NOACA RFP for a Telephone System

REVISED Addendum #1

September 16, 2013

Responses to 11 Questions - REVISIONS IN RED

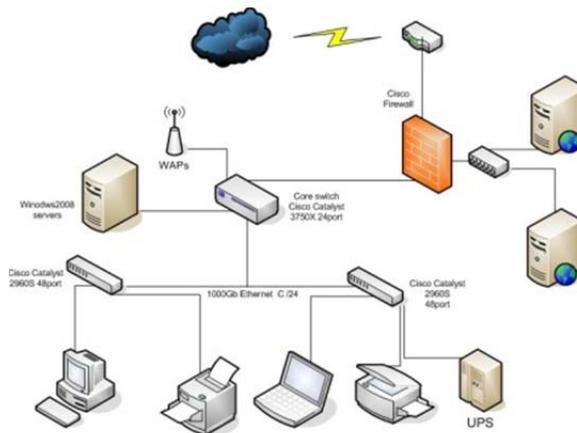
Q3: If NOACA will consider a hosted voice solution, does NOACA have a network diagram that shows NOACA's switching infrastructure?

A3: Yes, the drawing is attached.
